March 31, 2021

RE: Additional Comments Regarding the Hirshhorn Sculpture Garden Revitalization Project

Revised Alternative Plan

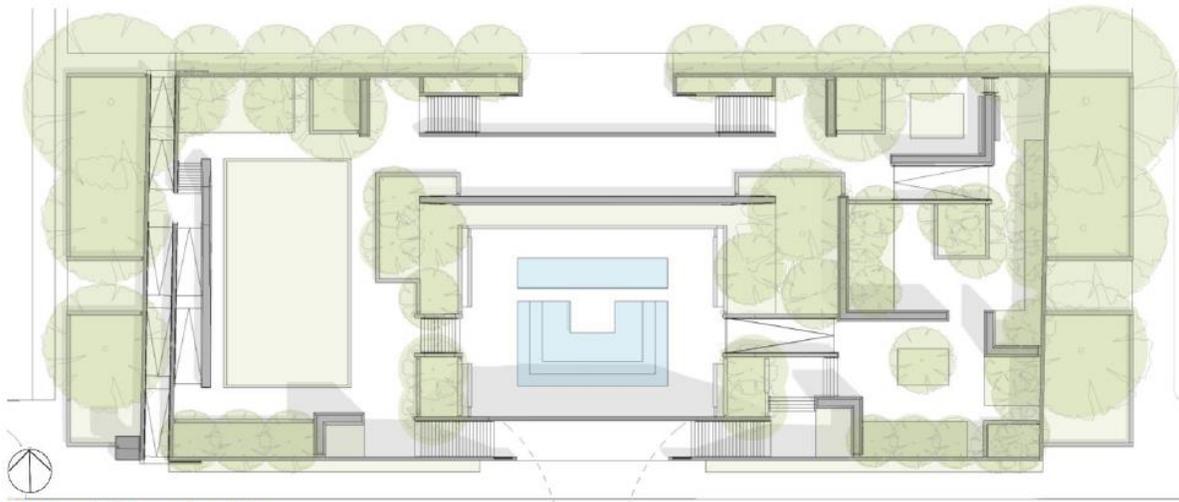
We also appreciated the follow-up email that was sent to consulting parties on March 17, 2021 to clarify that the Smithsonian Institution intends to move forward with the “Revised Alternative” which retains the original 1974 pool and augments it with a smaller pool to the south (as shown below) rather than the previously proposed “Preferred Alternative” which would have surrounded Bunshaft’s original water feature with a larger pool. This decision was not made entirely clear in the meeting, but it is an important distinction which we consider to be a meaningful step towards minimizing adverse effects on the historic Hirshhorn Museum and Sculpture Garden. As you are aware, we have long maintained that retention of the original pool was the minimum that should be done to acknowledge the significance of the Bunshaft/Collins design and we are pleased that this crucial change to the project designs has finally been made.

Despite this significant step forward, we share the concerns raised by some consulting parties that the second pool will detract from the importance and simplicity of the original design. If the Smithsonian is able to achieve its performance goals without an additional water feature, we would certainly welcome the elimination of the second pool. On the other hand, we also recognize the importance of balancing historic preservation goals with program needs. If the second pool is truly essential, the Smithsonian should commit to retaining the original pool's black granite stone edge and to heating the water feature year-round, as was suggested in the previously proposed "Preferred Alternative," so that Bunshaft's pool will be more clearly distinguished as an important and original element of the garden.

For similar reasons, we also echo many of the other comments made by consulting parties regarding the integral nature of aggregate concrete walls to Bunshaft's design and we continue to urge the Smithsonian to replace the central partition wall *in-kind* to help further minimize adverse effects on this important Modernist landscape.
